Appendix A

NOTICE OF PREPARATION
OF A DRAFT ENVIRONMENTAL IMPACT REPORT
AND PUBLIC SCOPING MEETING

PROJECT & PERMIT(S): Royal Vista Residential and Parks Project, Project No. PRJ2021-002011-(1) / Vesting Tentative Tract Map No. TR83534 (RPPL2021007149) / General Plan Amendment No. RPPL2021004860 / Zone Change No. RPPL2021007152 / Conditional Use Permit No. RPPL2021007151 / Housing Permit No. RPPL2021007161 / Environmental Assessment No. RPPL2021007150

Subject: Notice of Preparation of a Draft Environmental Impact Report for the Royal Vista Residential and Parks Project, SCH #2022100204, Los Angeles County Department of Regional Planning, Los Angeles County

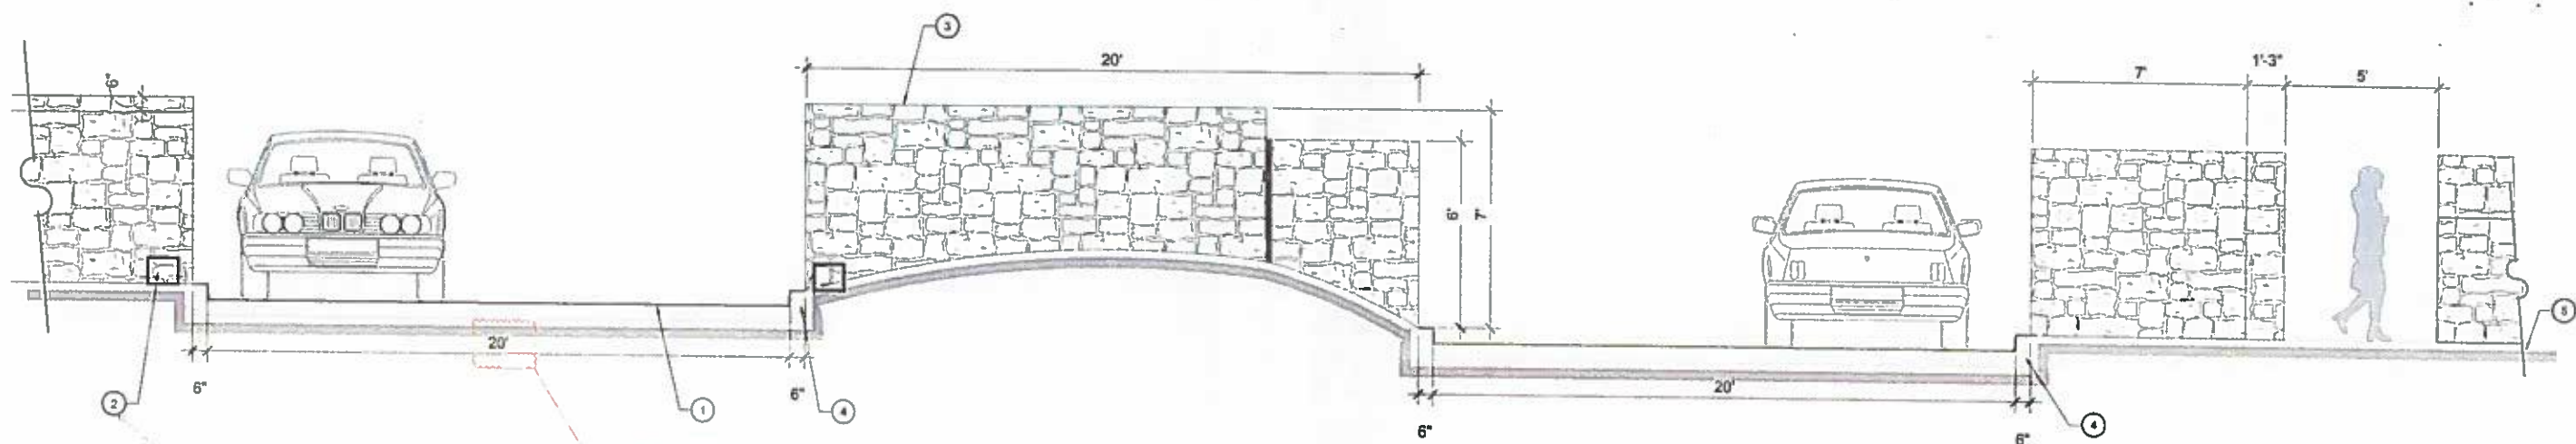
IF THIS IS FOR FIRE DEPARTMENT
ACCESS, 26'-0" CLEAR WIDTH FOR
ACCESS IS REQUIRED. VERIFY
WITH LACoFD
